**TOWN OF HERNDON, VIRGINIA
HISTORIC DISTRICT REVIEW BOARD WORK SESSION AGENDA
AUGUST 4, 2021
HERNDON MUNICIPAL CENTER
LARGE CONFERENCE ROOM, 2nd Floor
777 LYNN STREET
7:00 P.M.**

2. **APPLICATION FOR BUILDING ALTERATIONS, HDRB #21-009**, to consider an application for façade improvements to the commercial building located at 771 Elden Street, Herndon, Virginia and approximately 70 feet east of the Elden Street and Center Street intersection, and further identified as Fairfax County Tax Map 0162-02-0077 and portions of Tax Map 0162-02-0076 and 0162-02-0078. The property is zoned CC; Central Commercial; and consists of 4,512 total square feet of land. Owner: Elden Market LLC. Applicant: Michael Wijdoogen, MW Architects LLC.

Title: HPRB #21-009; Building Alterations; 771 Elden Street

2 Proposed Front Elevation
1/4" = 1'-0"

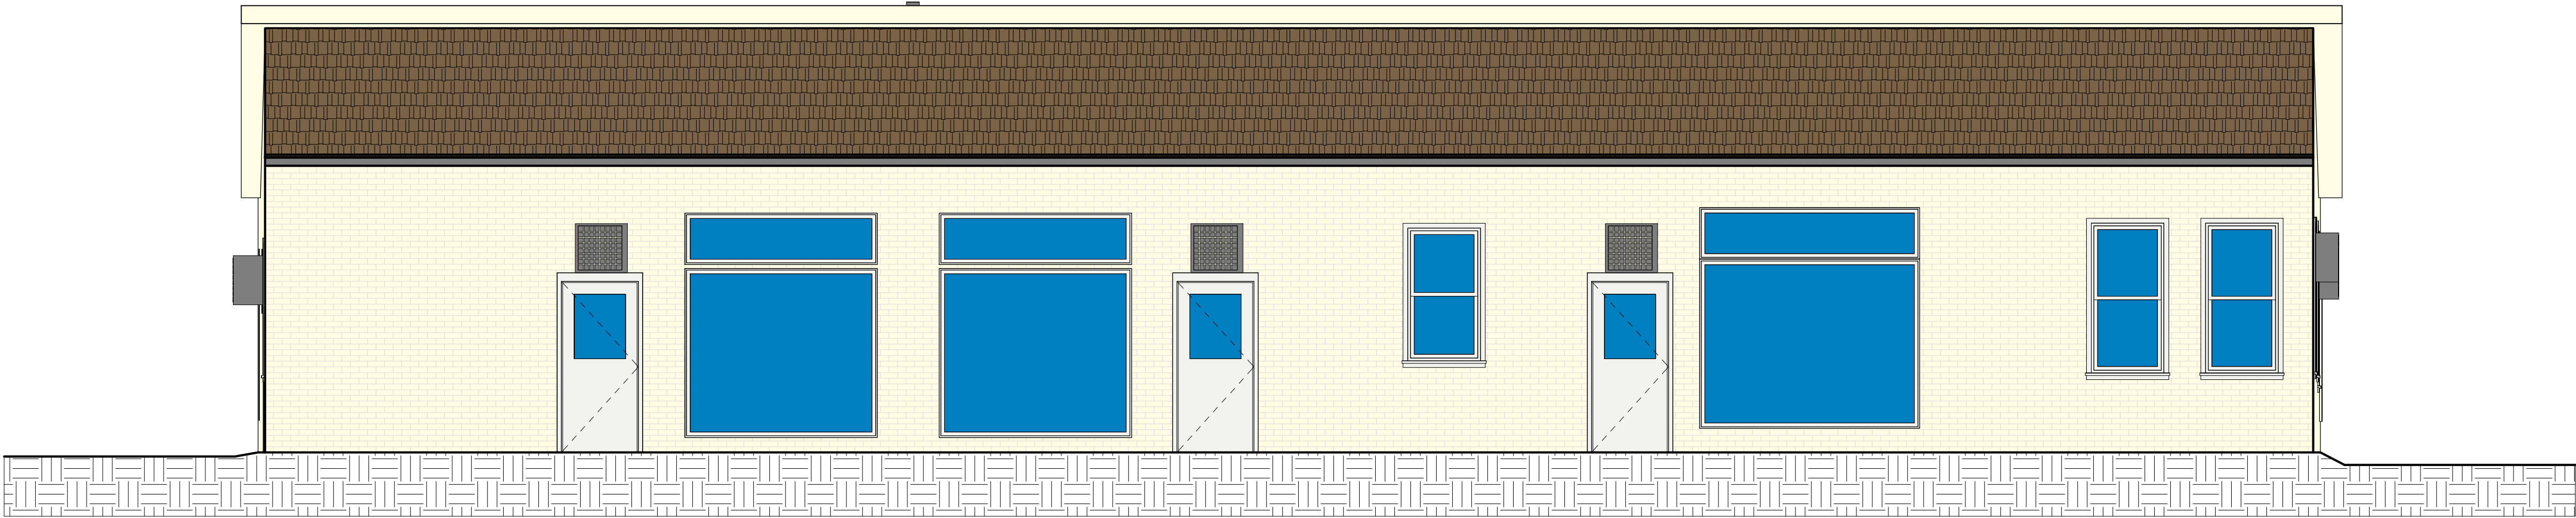
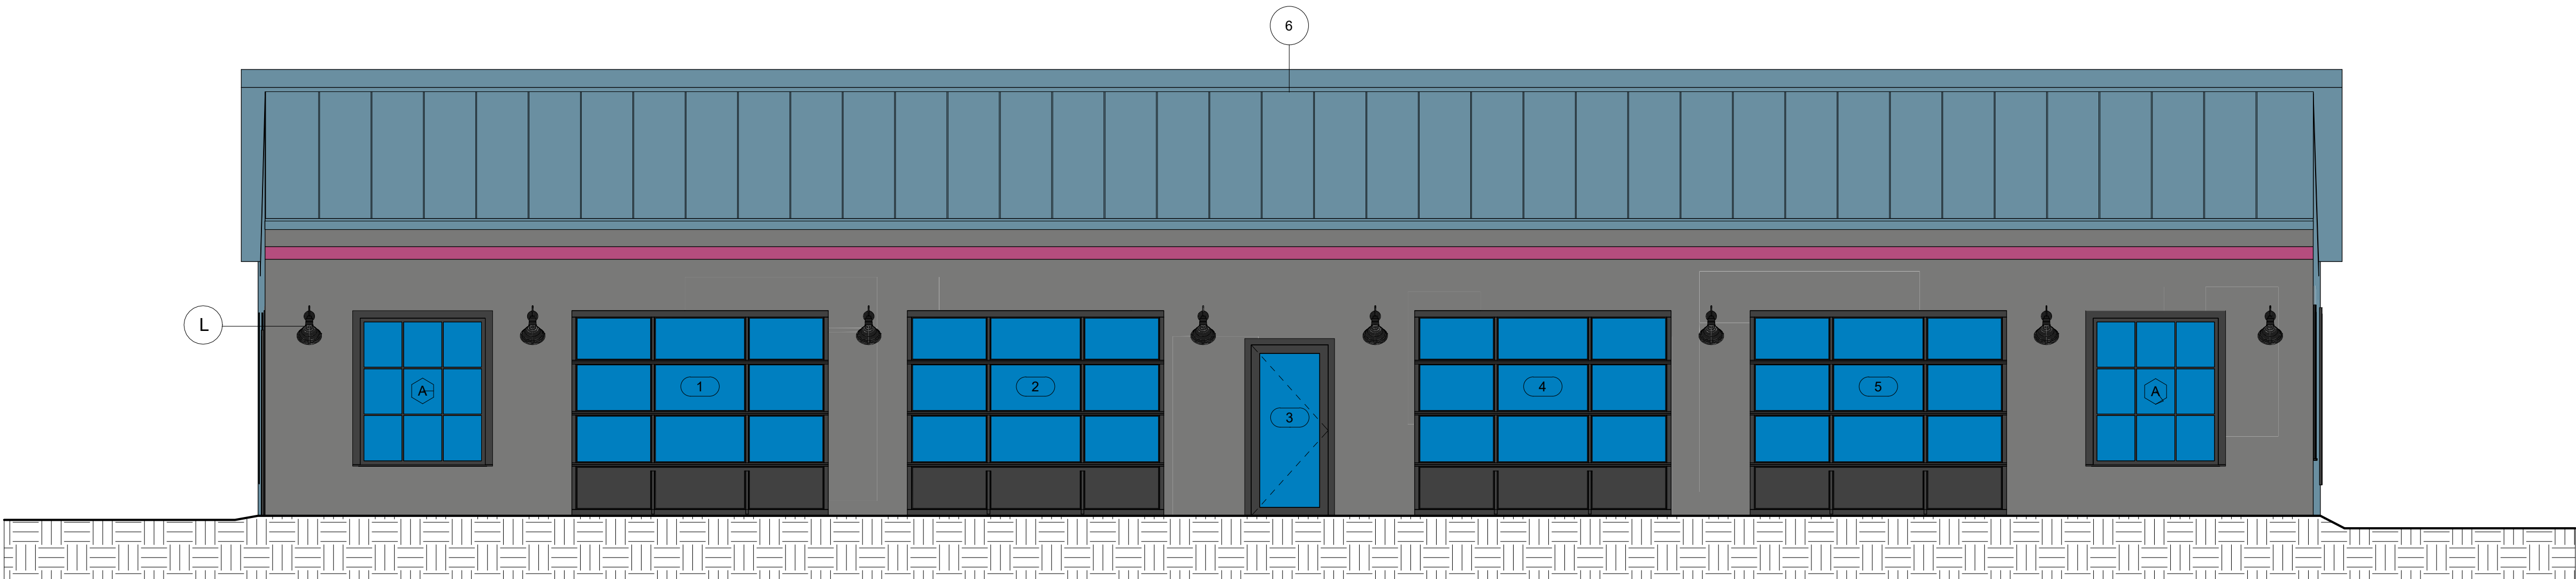
- Replacing 3 existing fixed glass storefront windows with 4 roll-up glass doors on the front elevation.
- Removing two existing half-light doors and relocated one existing half-light door on the front elevation with one full-light door.
- Removing three existing double hung windows on the front elevation with two larger fixed glass windows.
- Replacing the existing asphalt shingles covering the front façade awning with standing seam metal panels.
- Adding eight gooseneck lights on the front elevation.
- Removing four double hung windows on the west elevation and replacing with two larger fixed glass windows.
- Removing one double hung window on the east elevation with a roll-up glass door.
- Replacing a double solid metal set of doors with a set of full-light doors on the east elevation.

The proposed roll-up doors would be 8’ high by 10’ wide and have black anodized framing and bottom paneling. The windows size is uncertain based on the information provided; however, it would also have the black anodized framing. The proposed windows would similarly be framed with a black anodized metal frame. The standing seam awning cover would be metal; however, the seam height and panel width were not specified.

- a. The proposed windows and doors stay closely to the existing solid to void ratio of the façade, while maintaining the vertical alignments and reflecting the building’s simplicity in form.

- b. The use of roll-up doors reflect the original use of the building as a garage and service station. The use of roll up doors also serve an important function of activating the streetscape.

- c. The awning material change reinforces the commercial use and form of the building.
3. Staff has noted a couple items within this report with incomplete design information. The dimensions of the standing seam metal panels and the transparency of the glass have not been specified. Also, the size of the fixed glass windows proposed is inconsistent between the drawings and the materials table. This information should be provided to the HDRB for its review.

4. While staff supports the awning alteration, staff believes that removing the awning and returning the façade to its earlier design highlighted by its shed roof overhang would enhance the building’s original appearance while also re-introducing a contemporary form that is more consistent with the design of the adjacent Aslin Brewery Taproom.
